## **REMARKS/ARGUMENTS**

## **Amendments to the Drawings:**

**FIG. 2**

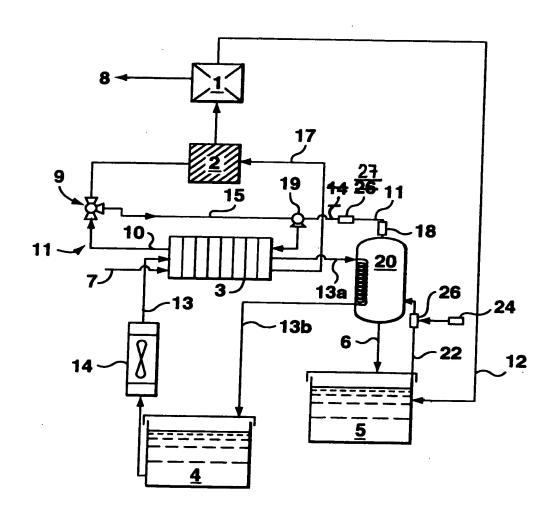
The Examiner further objected to the drawings under 37 C.F.R. 1.83(b)(4), on the grounds that the reference 14 has been used to denote two different elements. In response, the upper reference 14 in Figure 2 is being deleted.

The Examiner also correctly noted that the reference 26 had been used twice in Figure 2. The upper reference 26 is being changed to 27, and a corresponding amendment is being entered to the second line of paragraph 40, to refer to a "filter 27". Accordingly, it is submitted that this amendment brings the drawings into full compliance with the rules, and again no new matter has been added.

The attached sheet of drawings includes changes to Fig. 2. This sheet, which includes Fig. 2, replaces the original sheet including Fig. 2.
